Sent: 15/07/2024 11:08:48 AM
Subject: REV2024/1841
Attachments: submission_3_VM_a.pdf;

Re: REV2024/1841

This submission is in response to DA2024/0530 and subsequent REV2024/1841 at 77 Bassett St, Mona Vale.

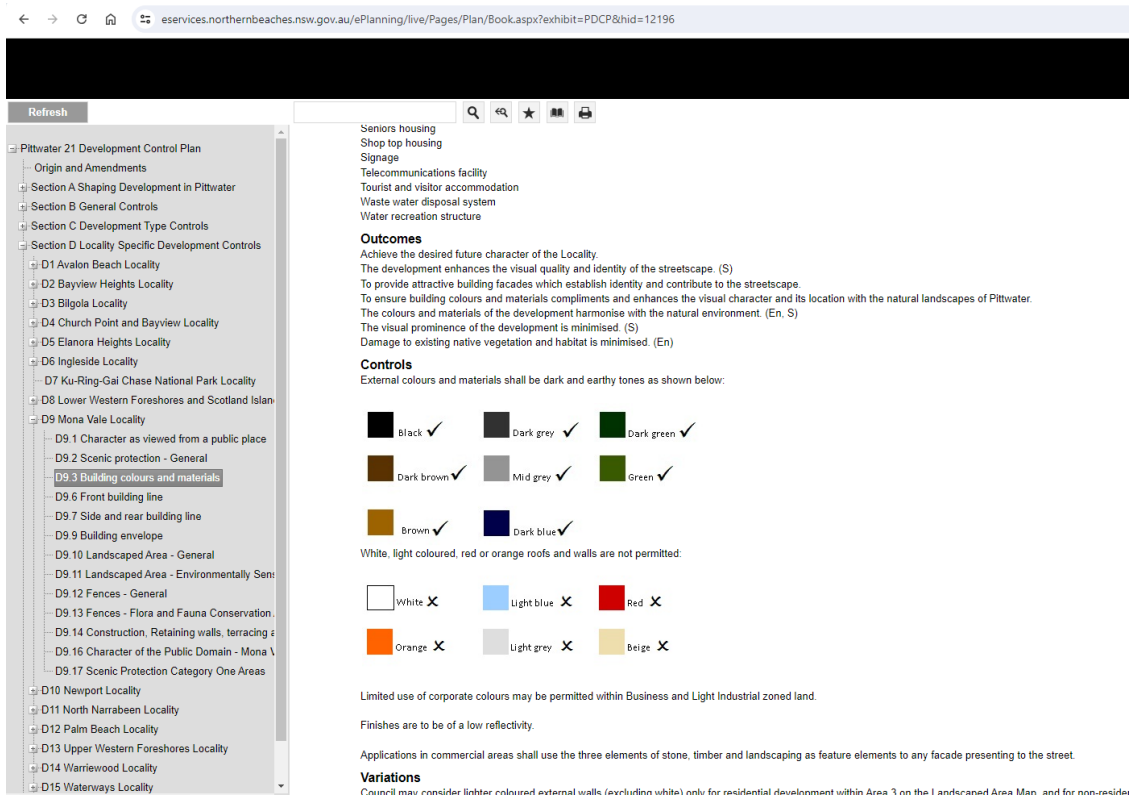
- The SEE prepared May 2024 (Revised July 2024) is flooded with photographs of the original building. The original building consisted of black, grey and brown coloured finishes, consistent with Pittwater 21 DCP. This is not a true representation of what the building looks like today. The applicant has painted the building red which is not permitted in Pittwater 21 DCP Section 9.3 refer extract blow.

The Applicant has undertaken external and internal works without Consent. So far, Northern Beaches Council has not taken any action in regards to the unauthorised works. Section 8 of the Local Government Act 1993 states: that its regulatory activities are carried out in a consistent manner and without bias. Will Council ask the Applicant to return the building to its original appearance?

Building as is, including signed car parking "Total Tools". DA not approve yet.
